Town of Breckenridge
Planning Commission Agenda

Planning Commission Staff Report

Subject: Stan Miller Master Plan Modification, Worksession, (original PC#2008006)

Re: Preservation Village at Reiling Road

**BRADDOCK WEST
 SUBDIVISION**

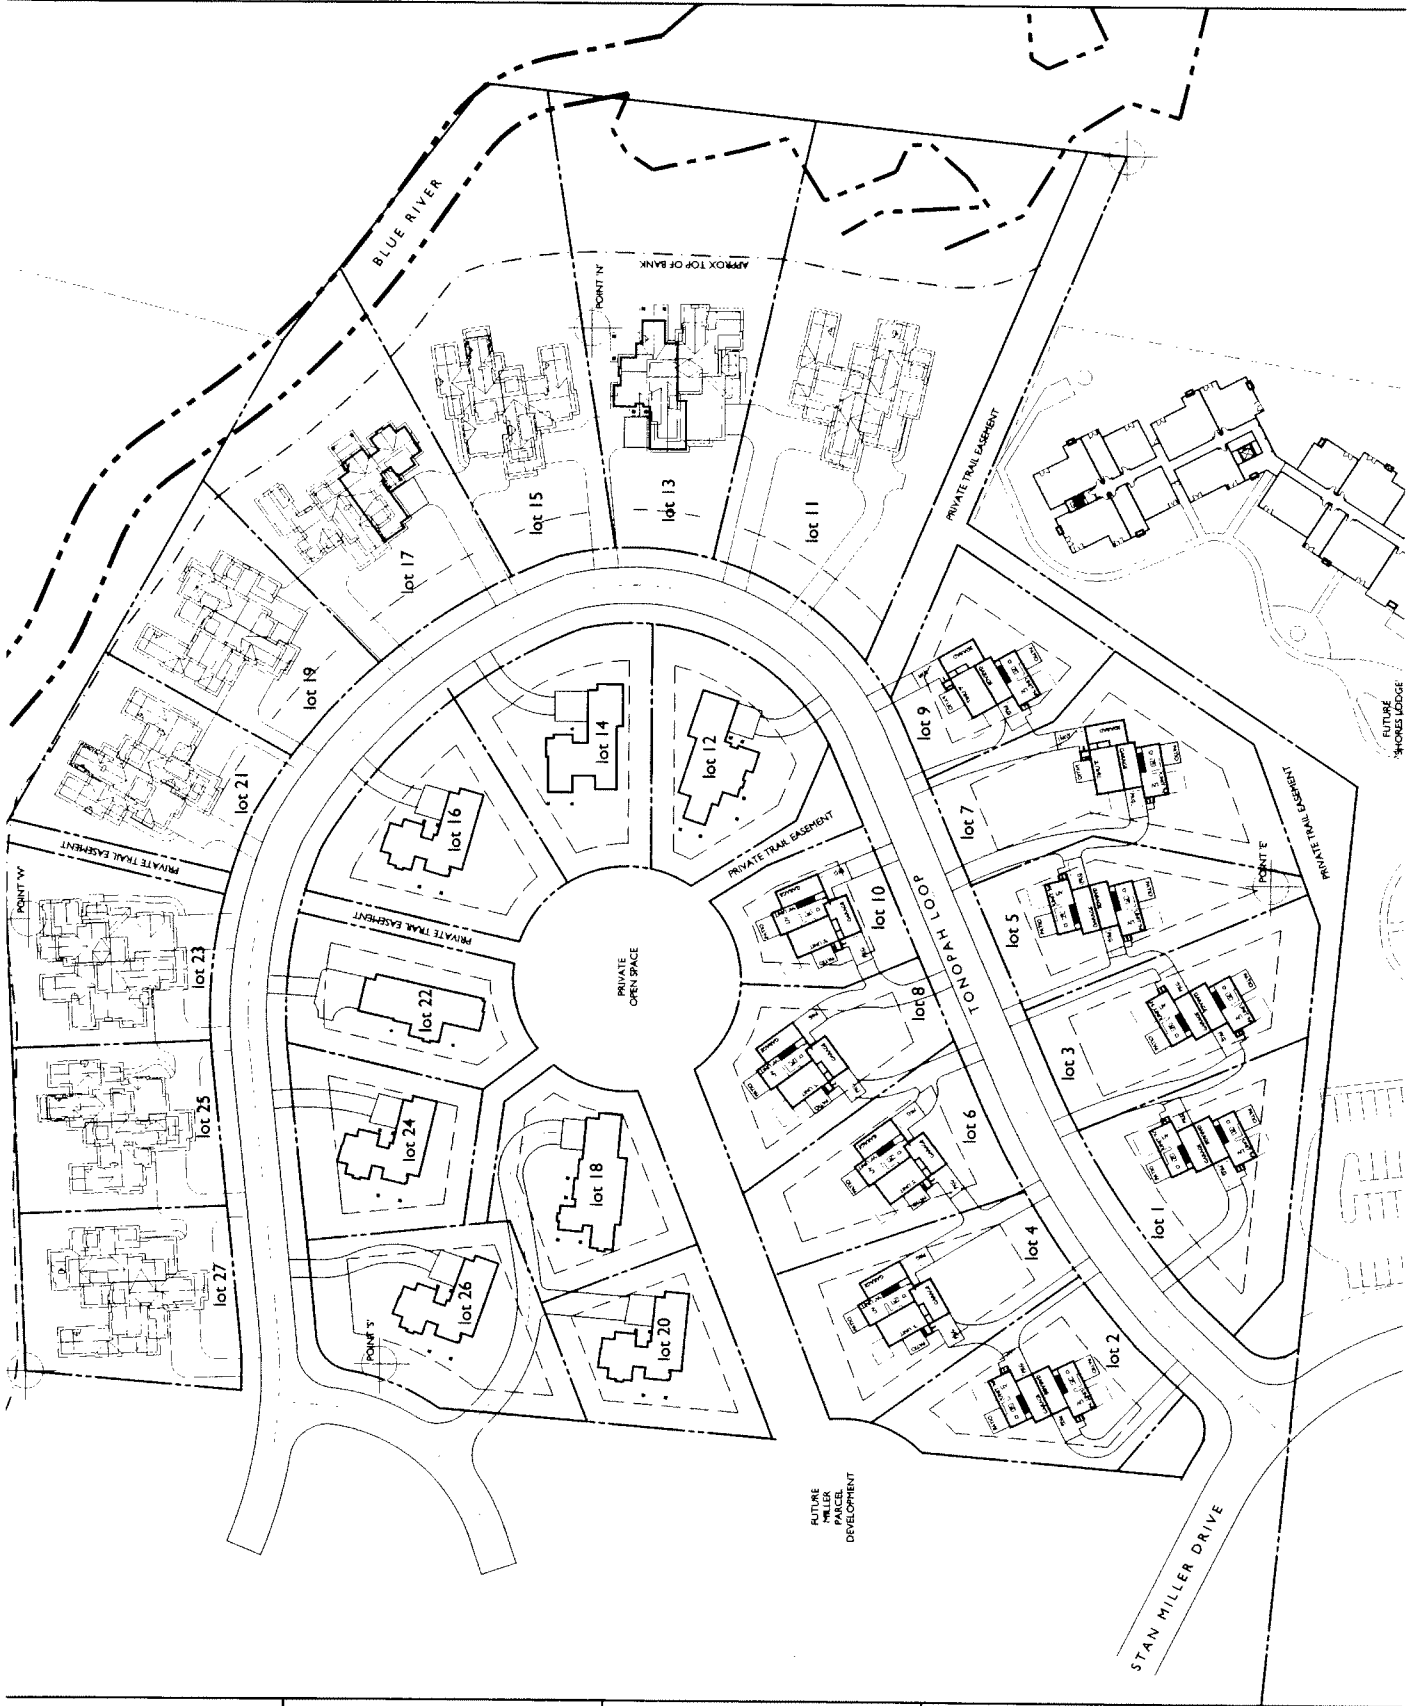
The illustrative plan shows the proposed duplexes where there were once single family homes on Parcel F. The separation between units is shown with a minimum 20-feet between structures. The Shores at the Highlands was approved with a separation between units of a minimum of 20 feet on the Master Plan. The duplexes and triplexes of Highland Greens were placed at a minimum of 19 feet apart for Phase I and 20 feet apart for Phase II. The suggested separation conforms to those on neighboring developments. Does the Commission support allowing a 20-foot separation between units for the duplexes on the Miller Master Plan?

SP-2.0

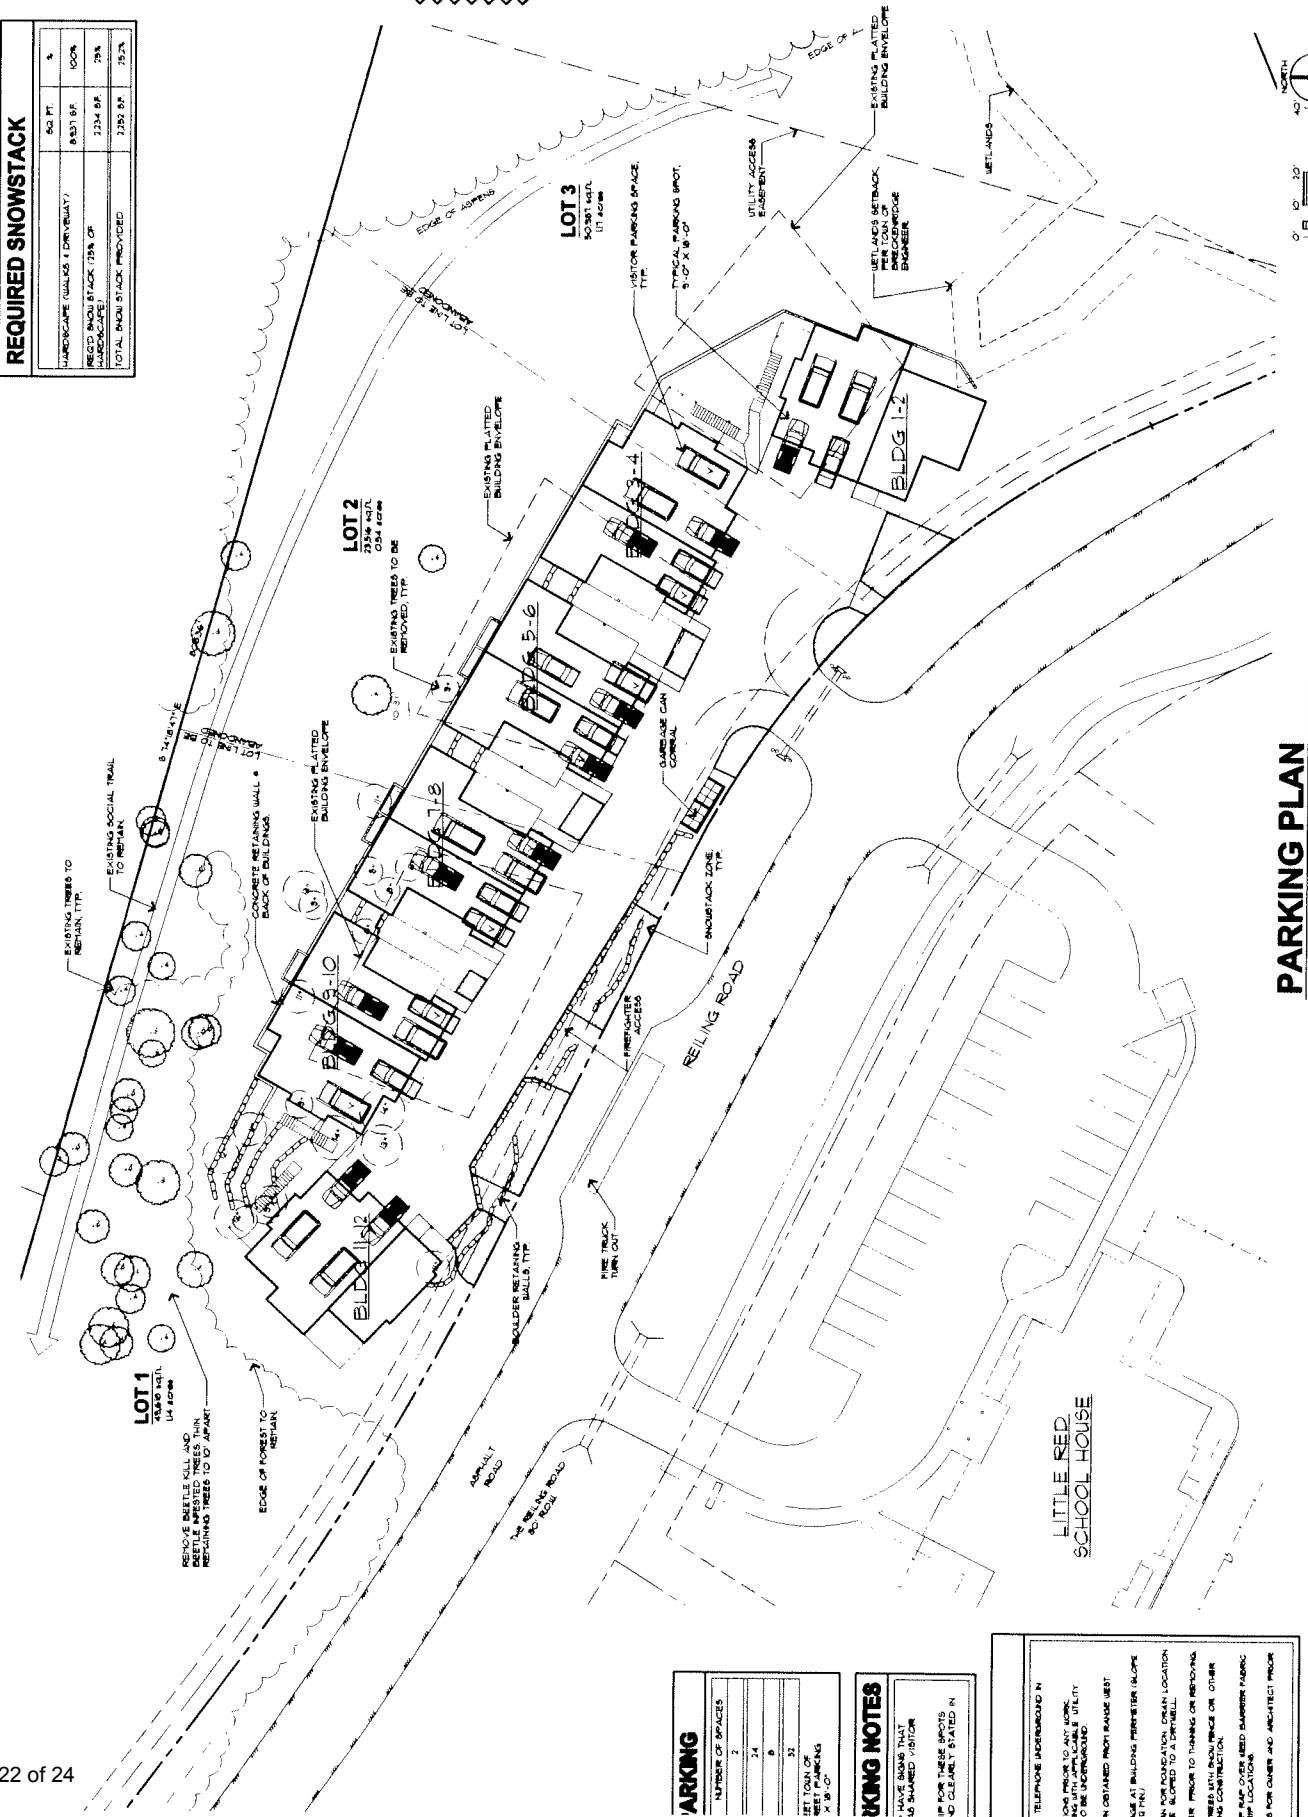
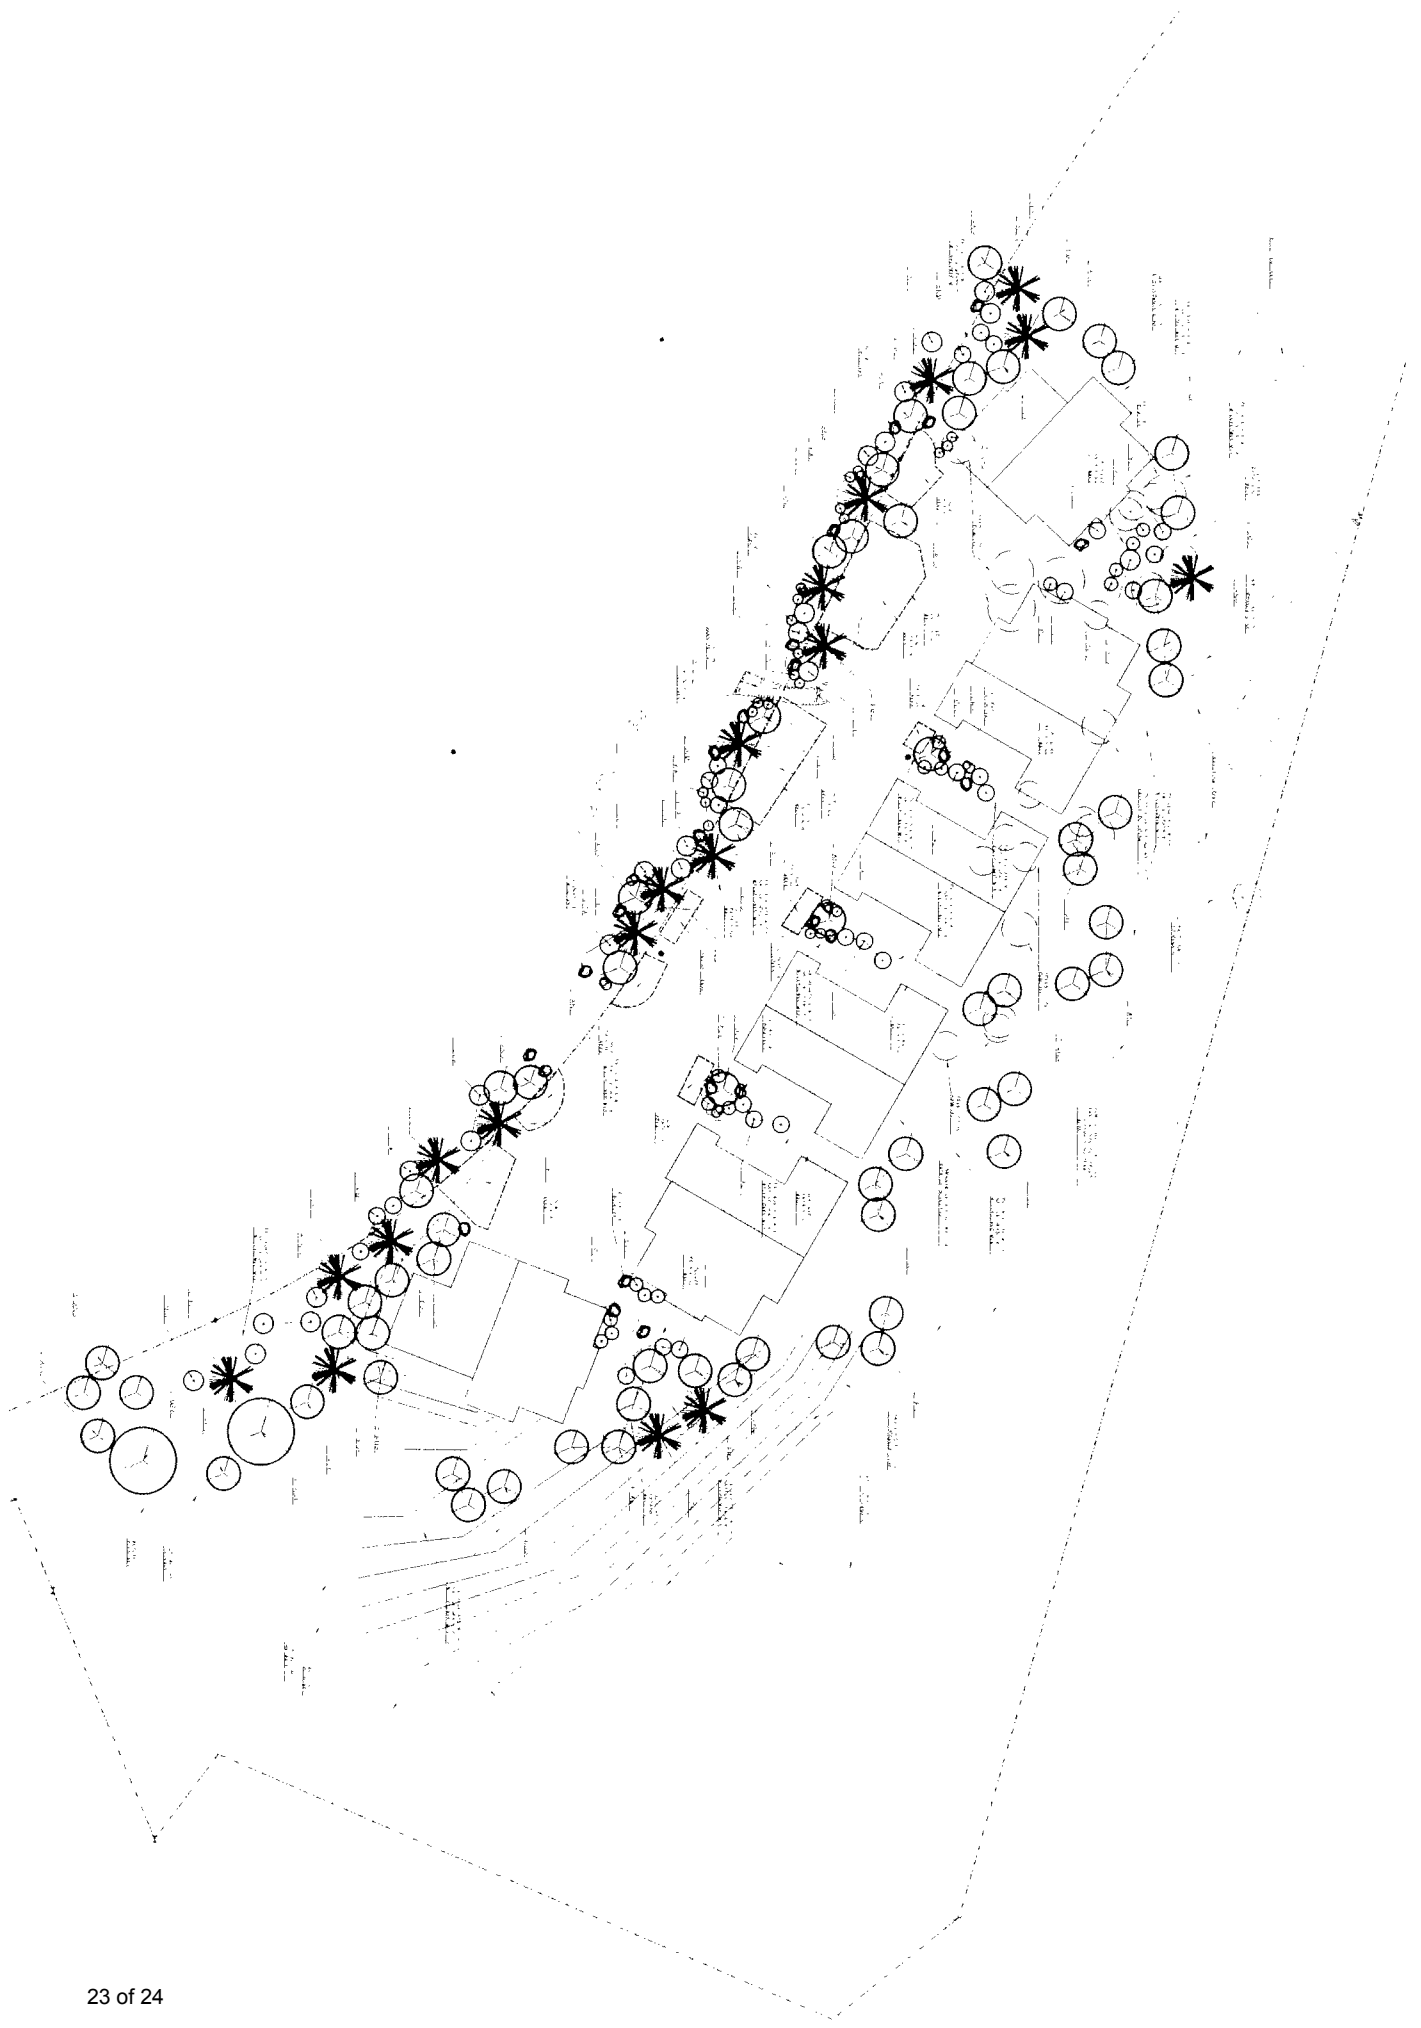
Since most proposed disturbance is located within previously disturbed areas and smaller portions of cut are in vegetated area, we suggest (-2) points under Site and Environmental Design / Site Design and Grading.

With a minimal front yard setback, the intensity of development has compromised site buffers at the south property line, we suggest (-4) points, under Site Buffering.

The exposed retaining walls meet every suggested design of this section of the policy. We suggest (0) points for the retaining walls. Does the Commission concur?

The drawings now show a comprehensive landscape plan: “(7) Revegetation measures, including but not limited to, seeding, netting, mulching, and irrigation for disturbed areas and cut/fill slopes are strongly encouraged. Cut and fill slopes should not exceed a 2:1 gradient.” for this we suggest (+4) points under Council Goals, Recreational Resources.

The applicant propose to dedicate and improve the existing social trail along north property line. This would include a platted easement and improvements to the surface per the Town’s Trail Standards. We suggest (+3) points under Community Need.
